**WILLIAMSON COUNTY, TEXAS**  
**CHANGE ORDER NUMBER: 13**

Project Name: CR 111 Westinghouse Road

New or revised plan sheet(s) are attached and numbered: 2, 112A, 114A

### CR 111 Westinghouse Rd Williamson County Project No. 22IFB39 Change Order No. 13

**METAL BEAM GUARD FENCE (SHORT RADIUS) MBGF (SR) - 19**

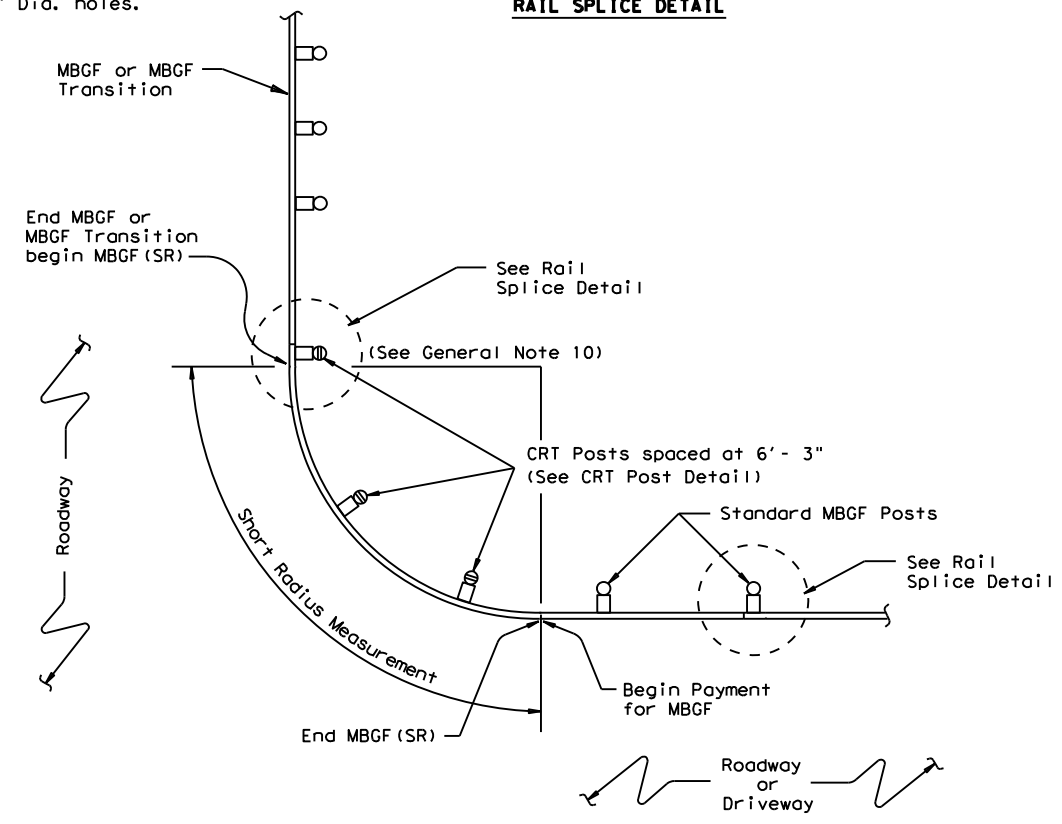
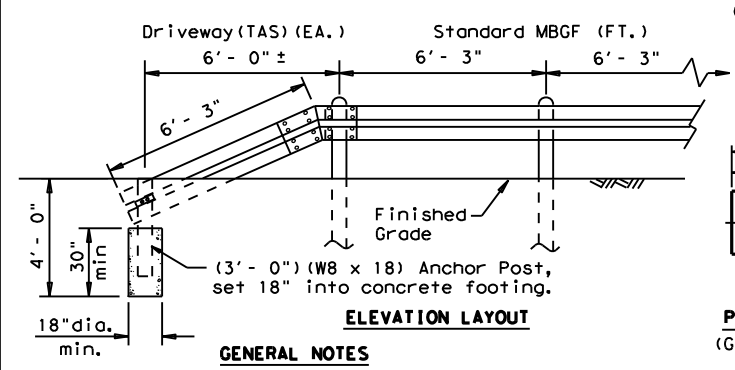
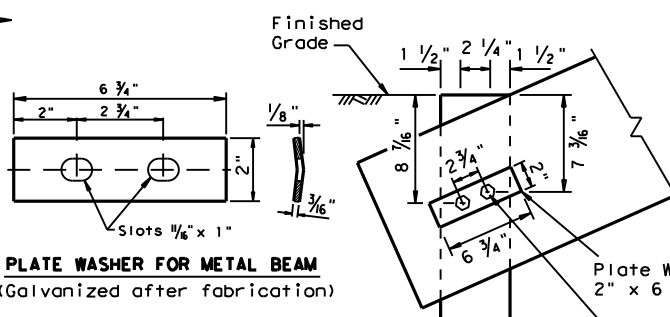
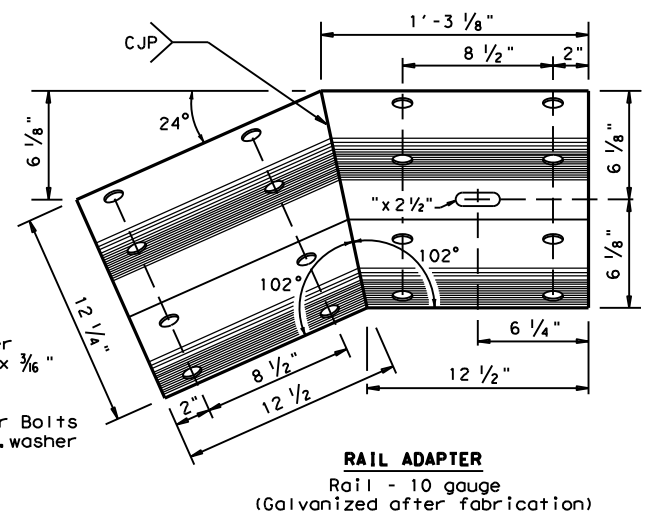
**1B. Design Error or Omission. Other.** This Change Order addresses the need for low fill post, concrete footing, and a driveway terminal section not accounted for in the plans. This Change order also addresses the incorrect called out sign post that were installed per plan. **2I. Differing Site Conditions. Additional safety needs.** This Change Order compensates the contractor for upsizing the stop signs at the new 4-way intersection. **4B. Third Party Accommodation. Third party requested work.** Eliminated the striping and created a right turn lane on northbound FM 1460 at CR 111 per TxDOT.

This Change Order compensates the contractor for installing low fill metal beam guard fence posts, concrete footing, and a driveway terminal anchor section that were not called out in the plans. Due to the lack of cover over Culvert 1, the guardrail could not be installed per plan and was switched to low fill posts with a concrete footing.

- The "Driveway" Terminal Anchor Section is ONLY to be used within driveway locations, where the ROW is limited and a standard 25 ft. (TAS) Terminal Anchor Section, is too long.
- Terminal anchor post shall be set in Class A concrete.
- All steel shall be galvanized after fabrication in accordance with Item 445, "Galvanizing."
